**Transient Groundwater Model Report
Numerical Flow Model Development
Beaumont Site 1
Lockheed Martin Corporation
Beaumont, California**

**RESPONSE TO COMMENTS, DATED OCTOBER 5, 2009,
TRANSIENT GROUNDWATER MODEL REPORT, NUMERICAL FLOW MODEL DEVELOPMENT,
LOCKHEED MARTIN CORPORATION, BEAUMONT SITE 1,
BEAUMONT, CALIFORNIA, DATED AUGUST 2009.**

Comments from Dina Kourda, DTSC (dated September 14, 2009)		
Comment	Response	Proposed Action
<p>Minor Comment:</p> <p>1. Section 1.0, Page 1-1: "... three-quarters of a pore volume of the 400 µg/L Total VOCs plume targeted for cleanup?, or about one-quarter of a pore volume..." should be removed.</p> <p>Specific Comments:</p> <p>1. The signature page should be revised to include a Professional Geologist's wet stamp with expiration date. An appropriate sized Professional Geologist stamp (no less than 1-1/2 inches) should be included in the report according to page 17 of the Geologist and Geophysical Act with Rules and Regulations dated 2007 http://www.geology.ca.gov/laws/act.pdf.</p> <p>2. Figure 3-3: Cross-sections B-B' through E-E' should be included in the report as they are included on the A-A'-A" figure.</p> <p>3. Table 3-1: Units should

Figure 4-8. Annual Change in Aquifer Storage: Comparison of model results with monitoring data

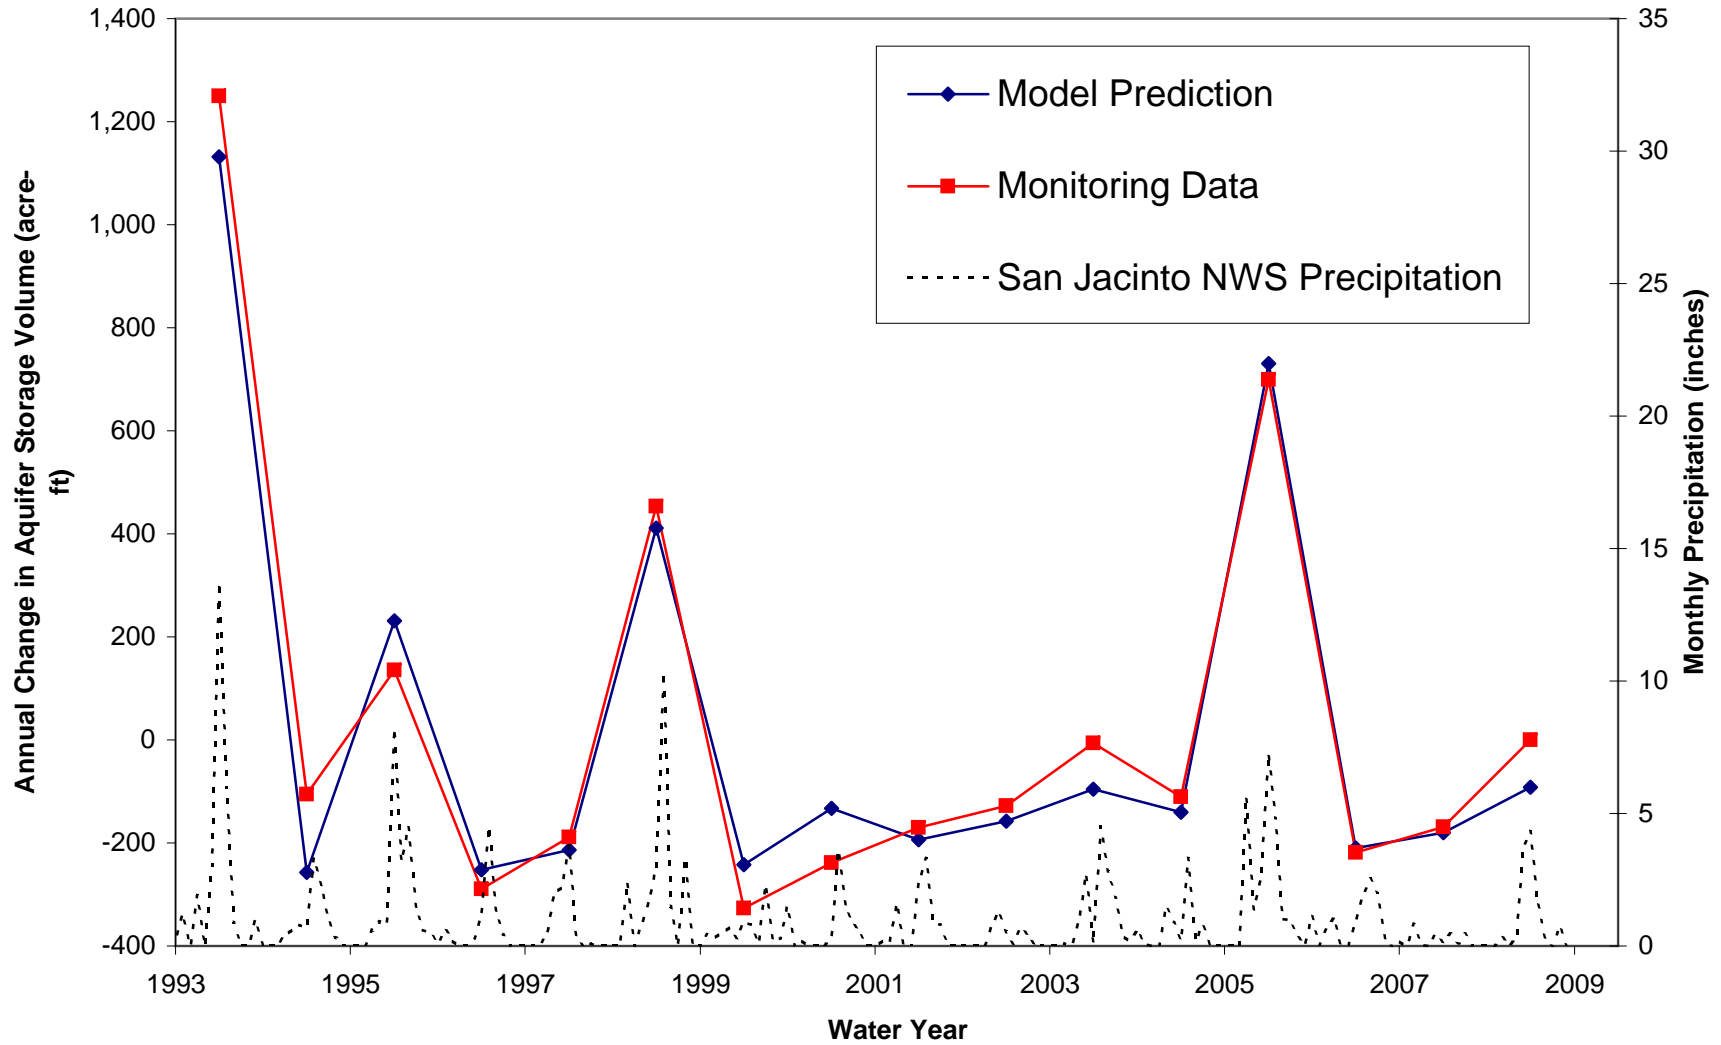
Comments from Dina Kourda, DTSC (dated September 14, 2009)		
Comment	Response	Proposed Action
4. Figure 4-8: The explanation should be reformatted so as it is legible.	The Figure has been reformatted to make the entire Figure more legible. Specifically, the dashed line and the explanation for it will be revised to make it more legible.	Reformat Figure 4-8 to make the Figure more legible as requested. Specifically, change the Legend text for "San Jacinto NWS Precipitation Station" so it is legible.
5. Section 8, Page 8-1: IRM should be defined.	The acronym "IRM" will be defined as requested.	The acronym IRM will be defined with Interim Remedial Measure in the Acronym List as requested.
